Addendum #01
NWAFC L16 Roof Replacement

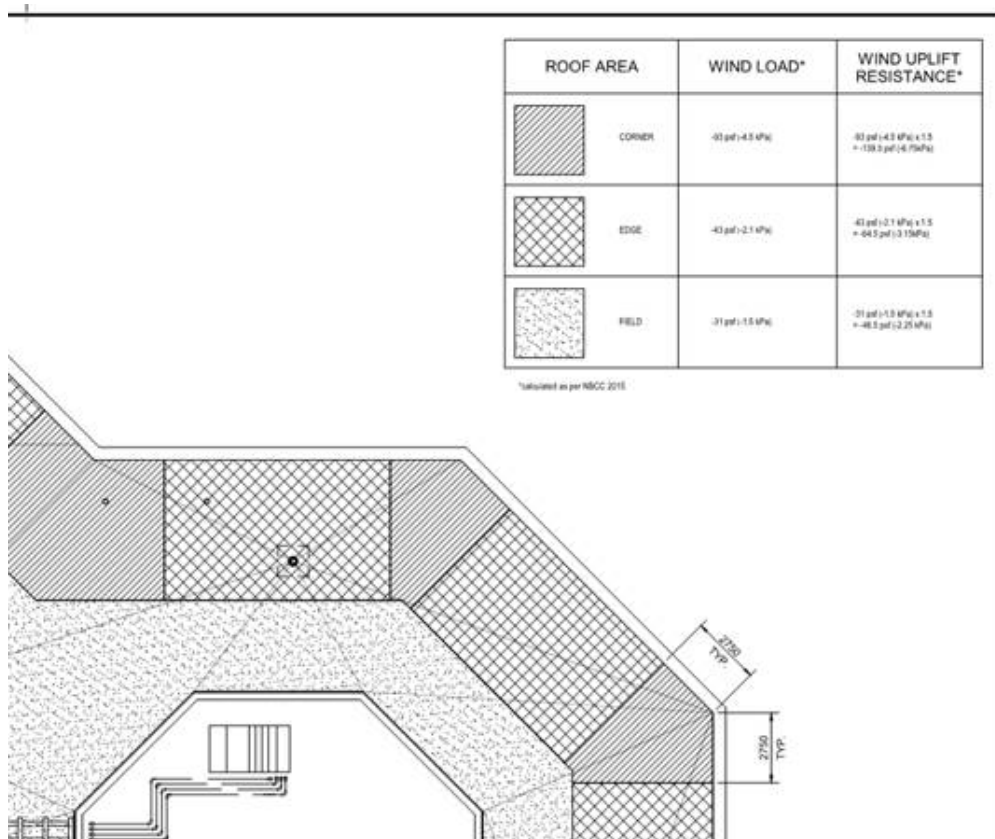
- .5 Can we substitute the specifications in 07 52 00 Part 2 Products 2.4.1 with the attached 2.2.3, Cover board components. – Reasoning - The mineral wool board cannot meet the required wind uplift when adhered.

Can we substitute the specifications in 07 52 00 Part 2 Products 2.5.1.1 and 2.5.1.2 with the attached 2.3.1, Base Sheet. - Reasoning - The Mineral wool board cannot meet the required wind uplift when adhered.

Answer: Protection board and base sheet can be separate components or a combined integral product. Either is acceptable as long as it meets the overall tested assembly requirements.
